TENNESSEE VALLEY AUTHORITY

In the Matter of the Application of ) Docket Nos. 50-390  
Tennessee Valley Authority ) 50-391

Your letter dated June 1, 1983 requested TVA to provide responses to specific questions concerning the analysis of sheetpile walls and seismic analysis of buried pipes. Enclosures 1 and 2 to this letter provide our responses to these questions.

ENCLOSURE 1  
ANALYSIS OF SHEETPILE WALLS

Figure 1

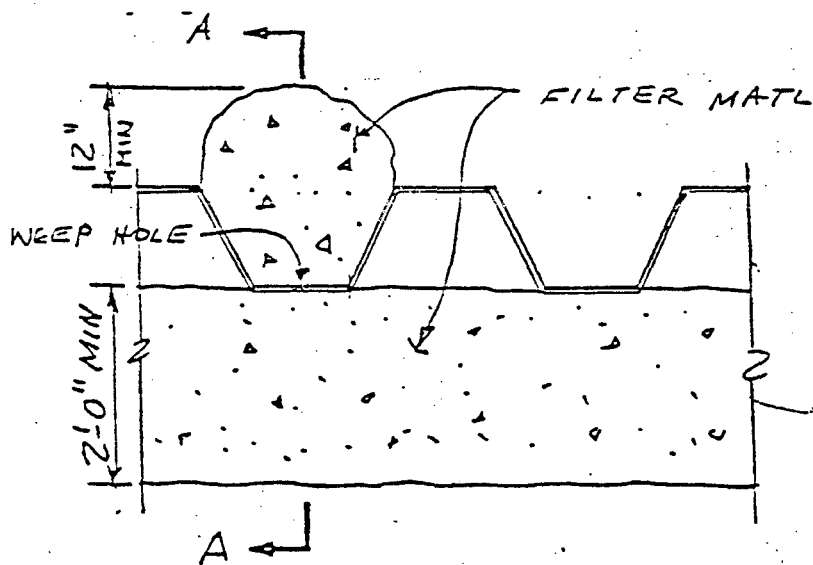
1. Identify the load cases and load combinations for which passive pressure with submerged conditions were used in the analysis.
2. Provide and justify the soil properties and other analysis parameters used in the additional investigation.
3. What are the factors of safety resulting from the analysis?

The load cases and load combinations using passive pressure with submerged conditions are listed in Table 1. The table also includes the soil properties and other parameters used in the analyses. The factor of safety for each case at the controlling section are shown on the right side of the table. Figure 1 shows a diagram of the controlling section, using submerged earthfill for the passive pressure.

PLAN

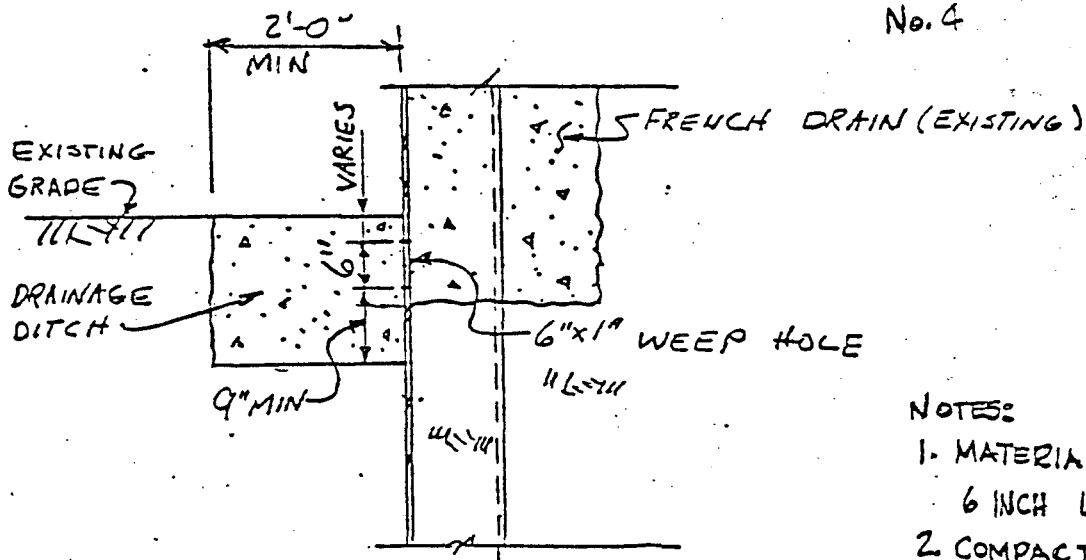
4. Provide a discussion with sketches illustrating the technique being used to correct the locations of the weep holes. How will you ensure the continued function of the weep holes in the future?

As shown on the attached sketch of a plan and section of the correction needed to allow the weep holes to drain, the earthfill covering the weep holes on the outside of the wall was removed to a depth (9 inches minimum) below the weep holes and replaced with a free draining granular material.

An adequate quantity of the drain material was placed along the sheetpile wall to ensure free drainage. In addition, the analysis tabulated for question 1 above shows that the wall is stable for the case where the backfill inside the wall is saturated to elevation 700.

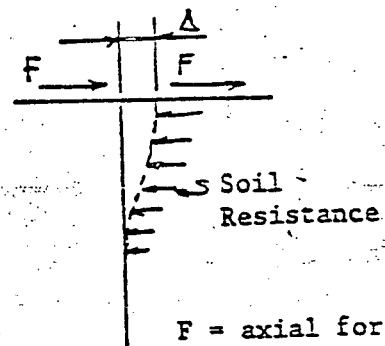
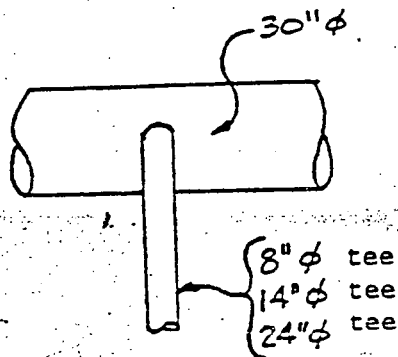
Provide the details of an analysis which demonstrates that failure of the small diameter pipes will not occur under seismic loadings. Include assumptions, failure criteria, calculation procedures and results.

The method used in the analysis of the tee-junctions was developed by Shah and Chu (1974)<sup>1</sup>. The worst case for the analysis was found when axial soil strain caused by the earthquake results in a differential movement in the small diameter pipe that is connected to a larger diameter pipe by means of a tee-junction.

The analyses were performed using the Shah and Chu (1974) procedure in conjunction with the applicable soil and pipe properties, and axial strain on the pipe due to the seismic event. The moments from the above analyses were used in the appropriate ASME equations and the resultant stresses were compared with the allowable stresses. The attached table provides the pertinent input data to the analysis and the results for the various tee-intersections.
